CORRIGENDUM - 3

Please refer to RFP 102021-22 published on **24.12.2021** inviting proposal from eligible bidders for **Request for Proposal for Supply, Installation & Maintenance of Backup Solution**. The corrigendum & reply to pre-bid queries are available on Bank's website <https://www.bankofmaharashtra.in> in the Tenders Section.

ANNEXURE-II RFP102021-22 (CORRIGEDUM - 3)

Expected Backup Architecture:

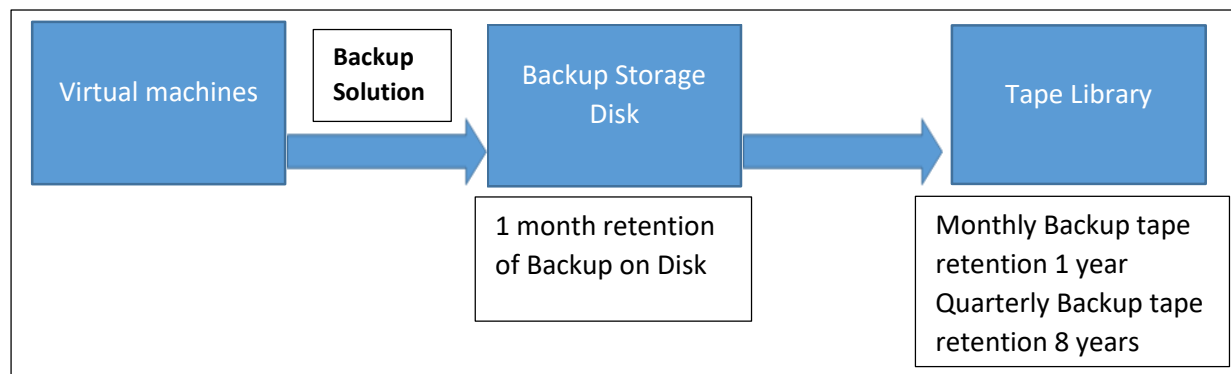
Current Backup Architecture:

Currently the Backup is directly taken from Virtual Machines to Backup Tapes. This takes a lot of time so everyday Backup is not possible for all the Virtual Machines.

VM Disk to Backup Tape

In order to prevent further Data loss and take every day Backup. Bank wants to switch to new architecture of Backup will be first taken on the Storage disk and then it will be moved to Backup Tapes.

VM Disk to Disk to Backup tape

Backup solution should be proposed keeping in the following factors in mind:

1. Every day backup is to be taken and any day data is should be available for restoration either from Disk or backup tape.
2. 300 TB front end data is the size raw data to be considered for backup is the initial phase and then from second year we have provision for additional 200 TB (Total 500 TB from second year onward) for coming 4 years.

3. The disk storage is to be proposed keeping the following two backup policy and factors into consideration which are:
 - a) Weekly full backup & daily incremental or Monthly full & daily incremental.

- b) Secondary Storage asked in the RFP required to take and store backup of 300 TB raw data(extended to 500 TB Raw data) for one month retention period and additional days considering the period required to move the backup to tapes.
At any point of time, Back up on disk will be 30/31 days (1 month) + additional days which are required to move the back up on tape.

- c) The secondary disk storage should be provisioned by bidder considering storing backup after de dup and compression.
 - d) Data growth rate of 1% per month is to be considered for next 5 years.

4. Bank will consider the extra time required for the first time full back of raw data taken by the proposed solution in our environment. After completion of initial full backup, proposed solution must complete the backup of both full as well as incremental data thereafter within backup windows of 10 hours.
